Product Change Notification					FAC improvement		
owner	creation date	release date	released by	change order no	rev	page	D10-013-731
dislercy	2017-02-09	2017-06-02	nowakfr	2010874	A	1 of 2

Product improvement to fulfil the enhanced glow wire requirements according to the updated standard IEC 60127-6:2014.

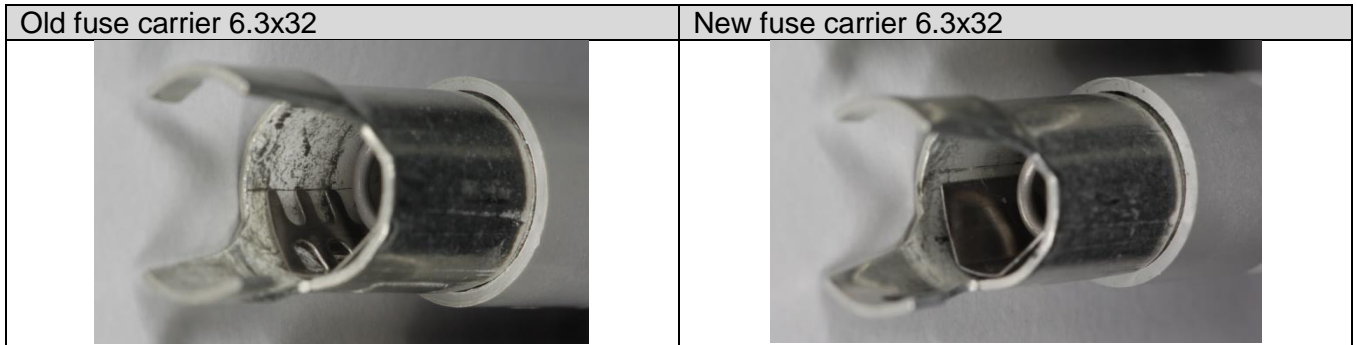
- Change of material
- Modified label
- Change of marking
- Improved voltage rating
- Improved electrical contact

The new materials fulfil the enhanced glow wire requirements according to the updated standard IEC 60127-6:2014 and are free of halogenated flame retardant and red phosphorus.

Old product approval		New product approval	
UL 512 16A, 400V CSA C22.2 no. 39 16A, 250V IEC 60127-6 (VDE) Cert. 6945 3.2W, 10A, 250V AC (6.3x32mm) 2.5W, 10A, 250V AC (5x20mm)		UL 4248-1 - CSA C22.2 no. 4248.1 16A, 600V AC or DC IEC 60127-6:2014 (VDE) Cert. 40045994 3.2W, 10A, 250V AC (6.3x32mm) 2.5W, 10A, 250V AC (5x20mm)	
Old label		New label	
Old product marking		New product marking

Form	Yes	Inscription on socket, holding spring and isolation material changed
Fit	No	No change for dimension
Function	Yes	Rating enhancement acc. to UL
Production Site	No	No change of the production site
Product Label	Yes	Approvals and configuration code on label
Packaging	No	No change in packaging
